Accessibility Assessment Report

Design Development Report
World Class End of Life Program
Tamworth Hospital

Prepared for:
Health Infrastructure

Revision 1
28 March 2025
Reference: N24096

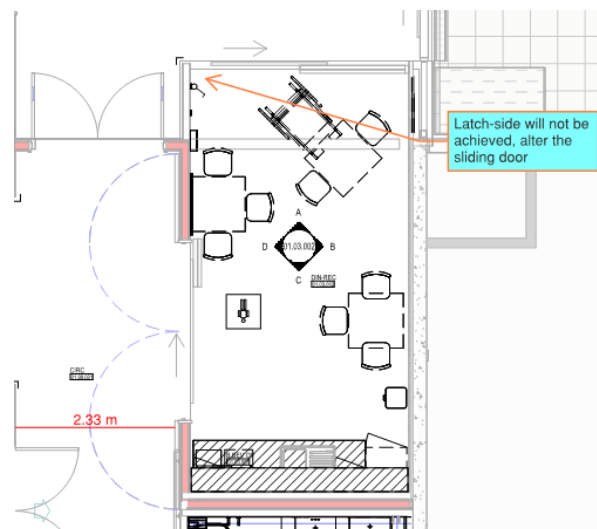
Does Not Comply: Latch-side clearance and/or doorway circulation are impeded at the following locations:

- + From the inside of the dining recreation room the sliding door when in the closed position does not achieve a minimum 530mm latch-side clearance it is currently obstructed from the wall. Also, verification is required if the door as accessed via corridor 01.99.001 is a sliding provided or swing door.

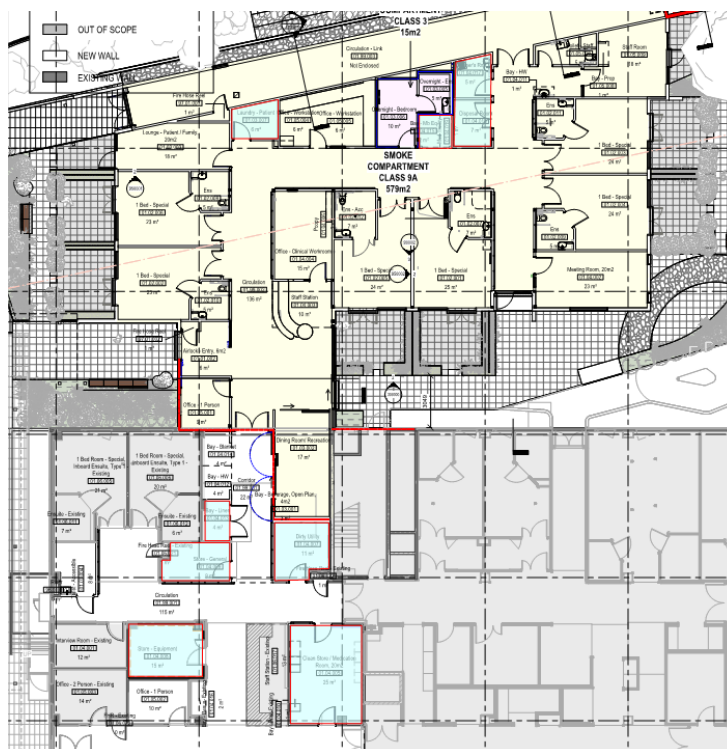
Further Information Required: The following areas as nominated in blue for the image below are to be confirmed by LHD as an exempt room at the Crown Certificate Stage:

- + Laundry pantry room 01.03.007
- + Cleaner room 01.04.017
- + Dispenser room 01.04.018

- + B Meq room 01.04.015
- + B Linen room 01.04.013
- + Store GN room 01.04.009
- + Dirty utility room 01.04.007
- + Store equipment room 01.04.008
- + Clinical medical room 01.04.005

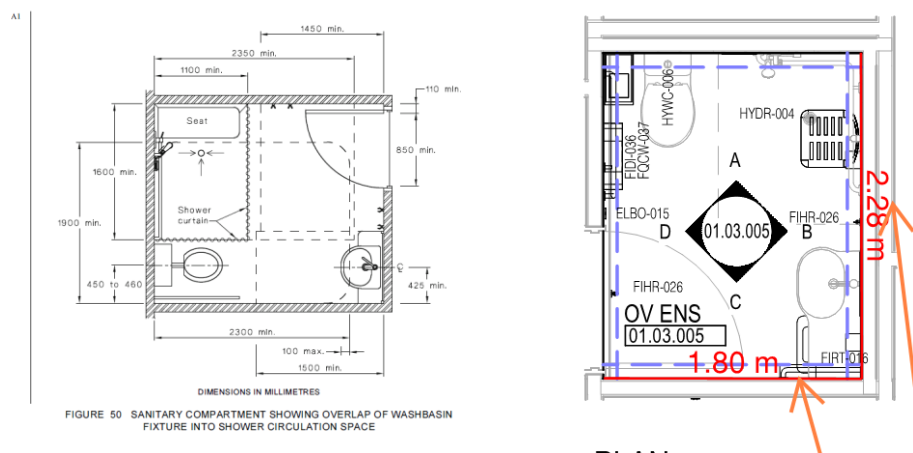
- + The overnight ensuite is required to be designed as an accessible WC, plan amendments will be required where the dimension of this room is to be reconfigured to achieve a minimum width of 1900mm and depth of 2300mm in accordance with figure 50 of AS 1428.1-2009.

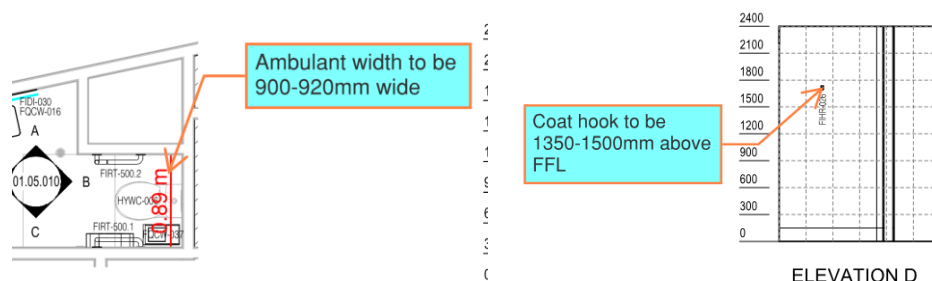
- + The staff ambulant WC 01.05.010, the width at the toilet pan is required to achieve 900-920mm, it was measured less than 900mm wide. Also, the coat hook is required to be 1350-1500mm above FFL.

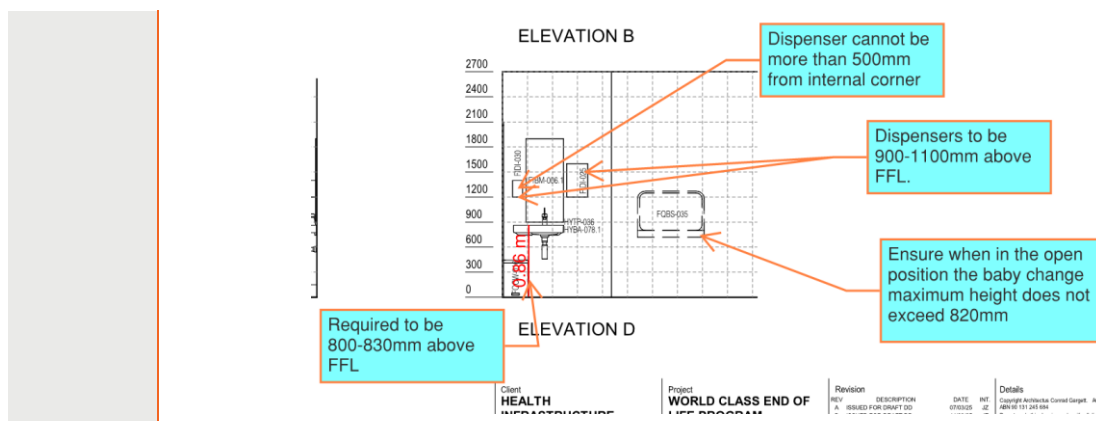
- + The ensuite accessible WC 01.02.012, the washbasin encroaches within the clear circulation space of the doorway a minimum 300mm distance is required.

The washbasin encroaches within the circulation space of the doorway, require 300mm clearance

- Remove the bin, a minimum 300mm circulation is required for knee & toe circulation space
